HITACHI MICROCOMPUTER TECHNICAL UPDATE

DATE	20 April 2001	No.	TN-SH7-318A/E
THEME	SH7615 notice on use of internal Ethernet controller.		
CLASSIFICATION	<input type="checkbox"/> Spec change <input checked="" type="checkbox"/> Limitation on Use <input type="checkbox"/> Supplement of Documents		
PRODUCT NAME	HD6417615ARF	Lot No.etc.	ALL
REFERENCE DOCUMENTS	SH7615 Hardware manual	Effective Date	
		Permanent

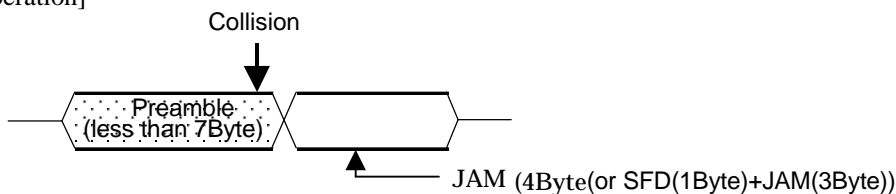
In the case that collision occurs during preamble, based on the IEEE802.3u, SH7615 has to continue to transmit preamble(7Byte), SFD(1Byte), JAM(4Byte) before it terminates the transmission. But SH7615 stops transmitting preamble on the way and transmits 4Byte JAM(or 1Byte SFD + 3Byte JAM) sequentially before it terminates the transmission and gets into the state of waiting retransmission.

[IEEE802.3u operation]

[SH7615 operation]
